From: Colin Fiske [REDACTED]
Sent: Monday, August 07, 2023 12:48 PM
To: Scott Davies; Peter Lehman; Judith Mayer; Dan Tangney; Matthew Simmons; Joel Yodowitz; Abigail Strickland
Cc: David Loya
Subject: Comments for 8/8/23 Planning Commission Meeting

From: Fred [REDACTED]
Sent: Monday, August 07, 2023 11:21 AM
To: Delo Freitas; David Loya
Subject: Draft Gateway Area Plan -- Version 3, July 11, 2023

From: Fred [REDACTED]
Sent: Wednesday, August 09, 2023 8:04 PM
To: Scott Davies; Dan Tangney; Judith Mayer; Matthew Simmons; Peter Lehman; Joel Yodowitz; Abigail Strickland; David Loya; Delo Freitas; Jennifer Dart
Subject: Notes from the Planning Commission meeting - August 8, 2023

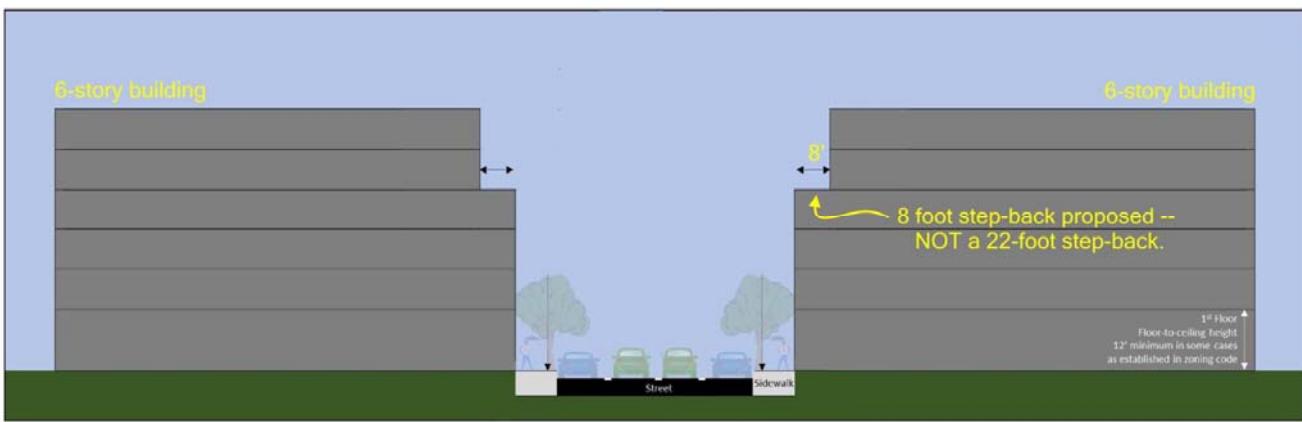
Please keep in mind that **a city bus is 8'-4" wide -- plus the mirrors.** A semi-truck is 8'-6" wide plus the mirrors. With the mirrors, a semi-truck can be up to 10 feet wide. Below, from the US Dept of Transportation:

My recommendation would be for **10' lanes** on streets that are **not intended for bus transit traffic or regular truck traffic** -- and 11' lanes for those streets. Yes, we know that every foot of lane width (which equals 2 feet on a two-lane two-way road) counts... on K Street, in particular. On the 50' width of K Street, there could be an 11' northbound lane, an 11' southbound lane, and one 8' lane of parking. Total is 30' -- leaving 20 feet for, say, a two foot increase in sidewalk width on each side (4'), two 6' bike lanes (12') and two 2'

buffers with pylons (4'). Without the one parking lane, there is even more flexibility, of course -- but the one parking lane can certainly fit.
